SAFETY RECALL N476 AND REVISED N335 REPAIR PROCESS OVERVIEW AND CARE POINTS

Safety Recall N476

Recall Action
Number: N476v2

Door Will Not Latch

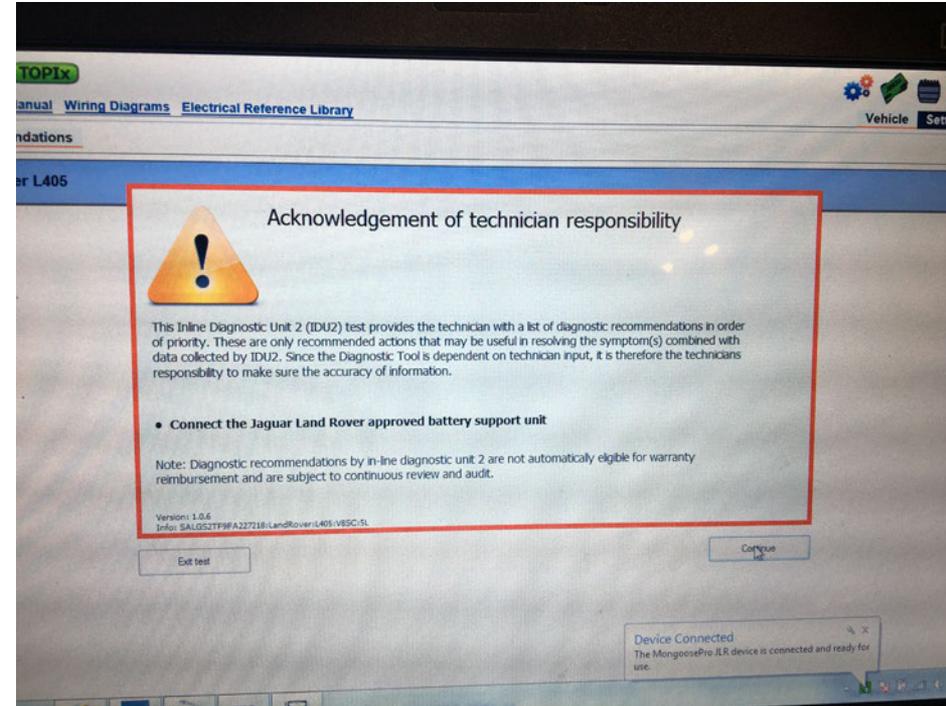
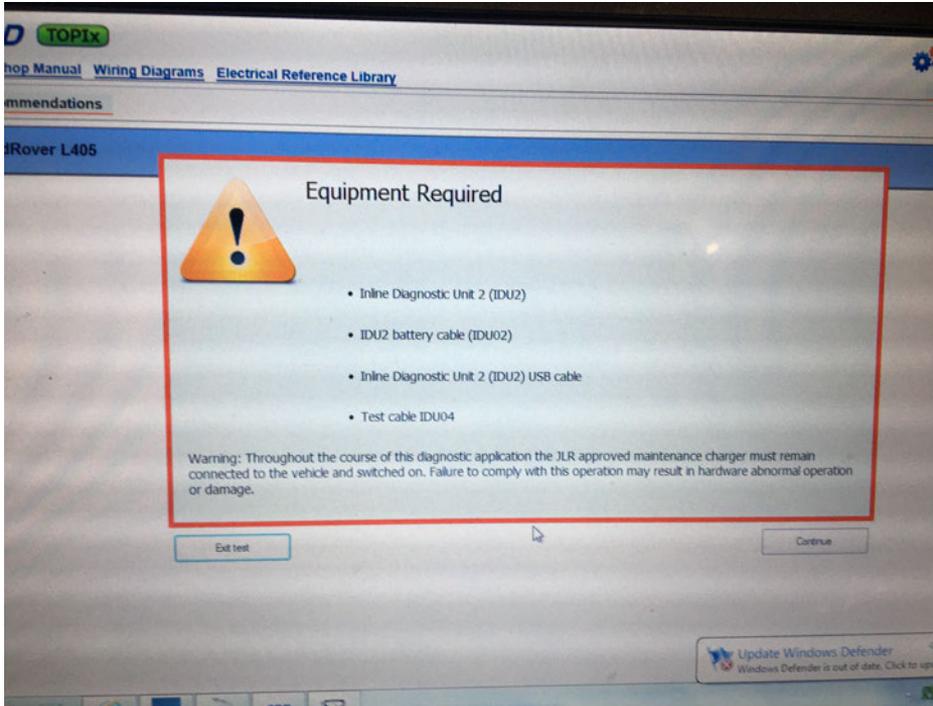
The power door locks must be operational before attempting to perform this test procedure.

Ensure that an approved battery maintainer is connected to the vehicle and that the battery voltage is within range.

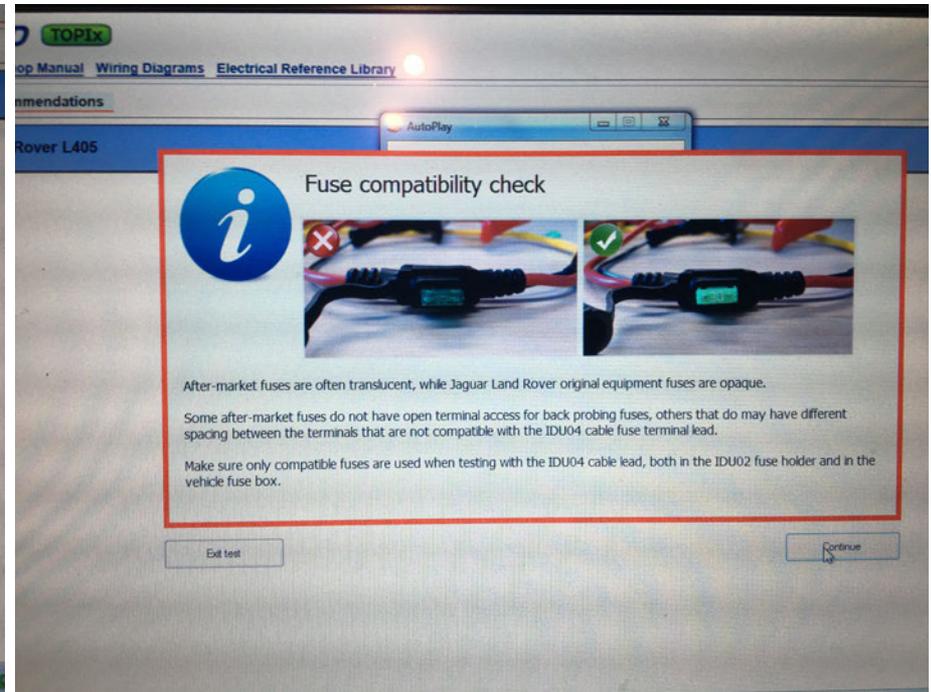
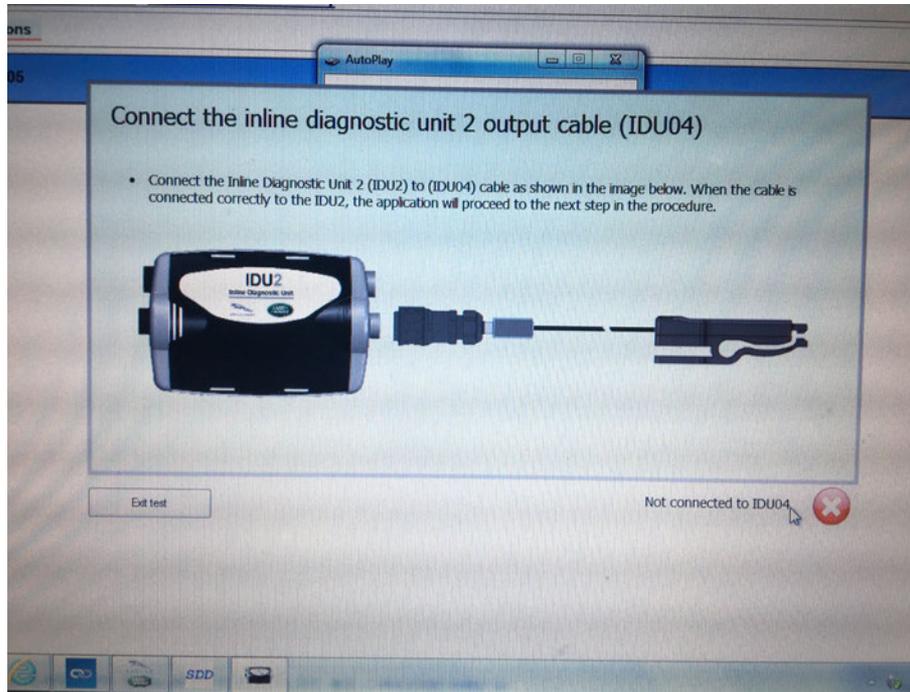
Ensure that the IDU04 cable is connected to the correct fuse.

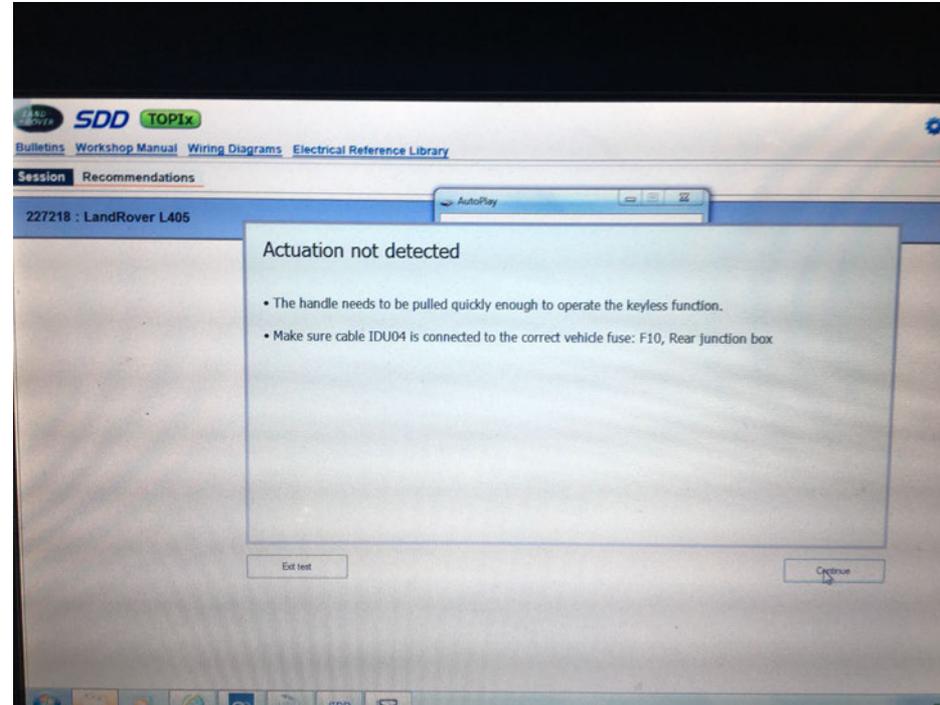
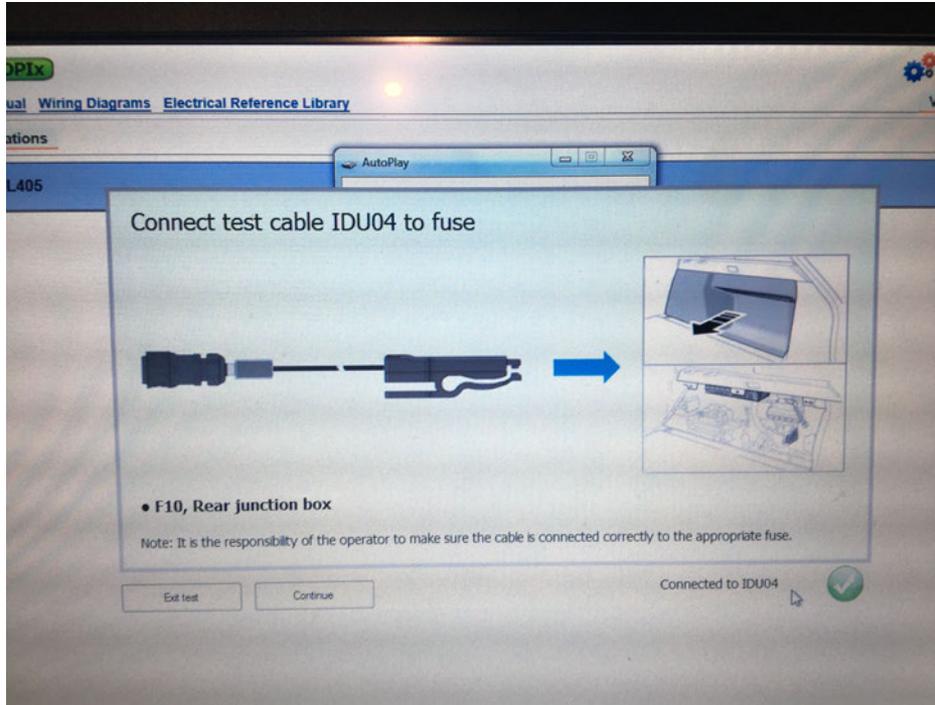
The door handle must be pulled quickly enough from when reaching for the door handle to test the Fast Unlock/Open Actuator properly.

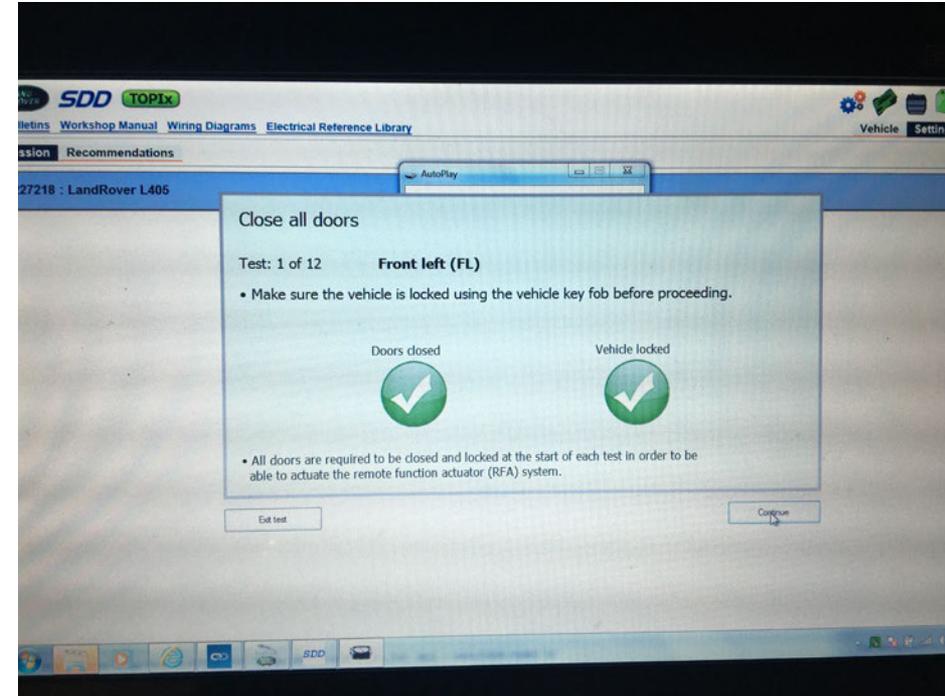
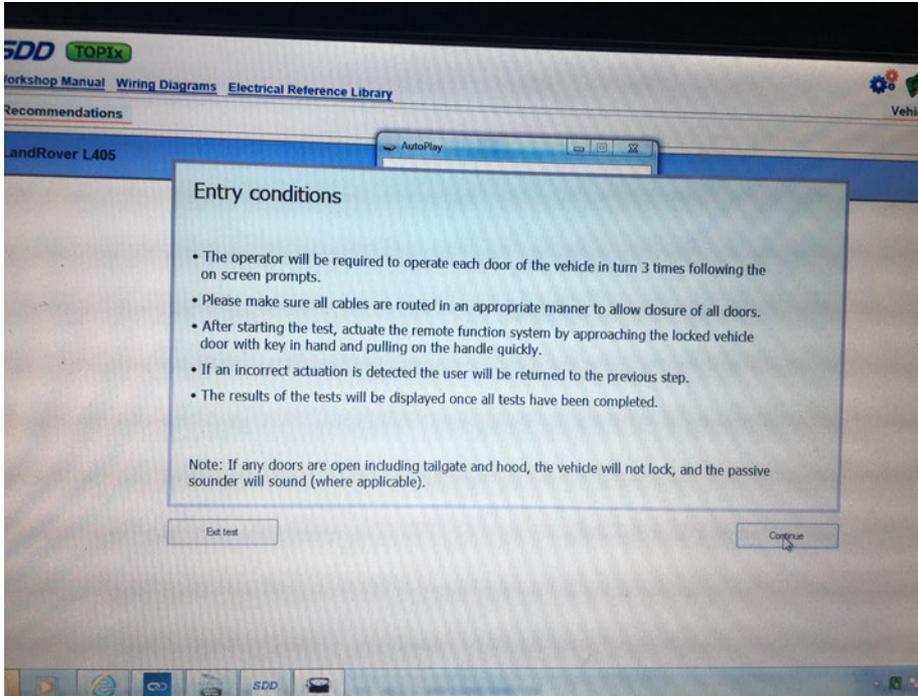
During N335 IDU2 testing, each door latch was tested 3 times. With the new IDU2 test procedure, each door latch is tested up to 5 times to ensure results.

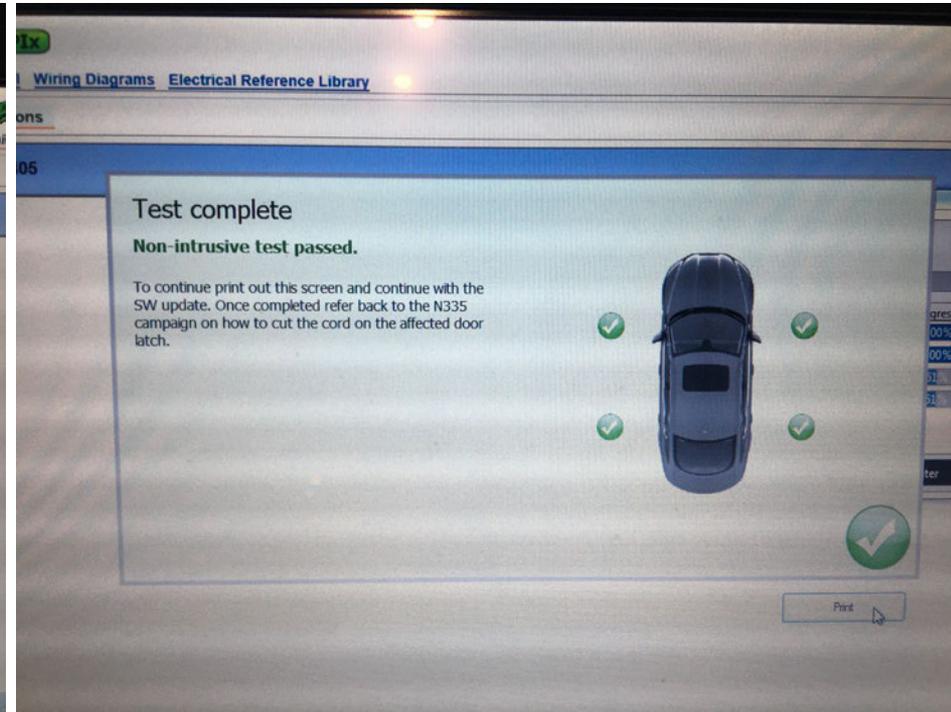
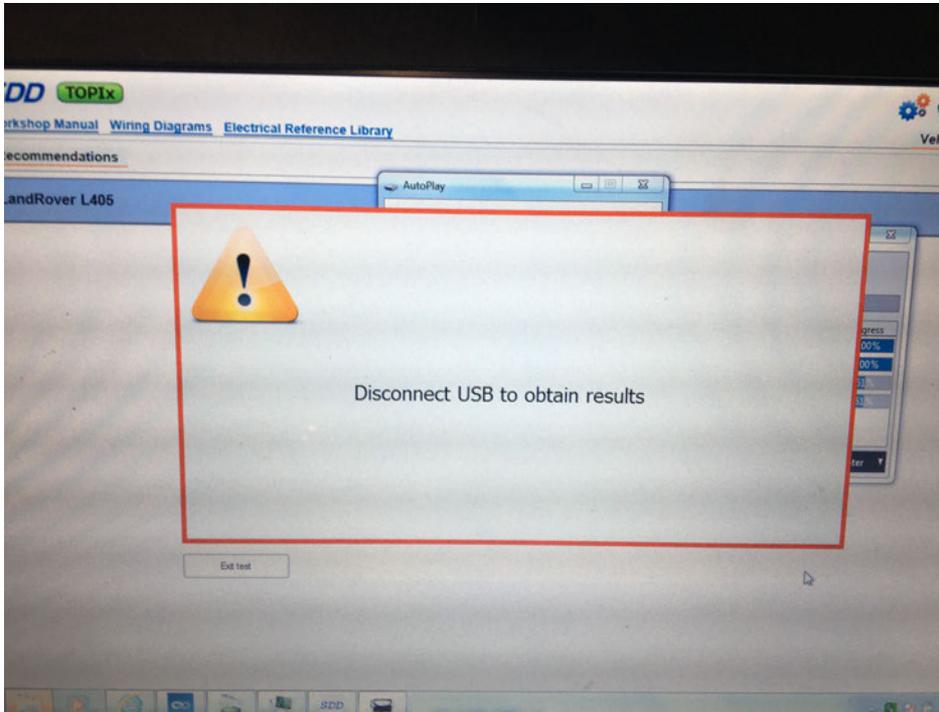
Upon completion of all SDD steps if any door latch fails the test, refer to the bulletin for service instruction on cutting the door latch fast unlock/ open actuator cord.
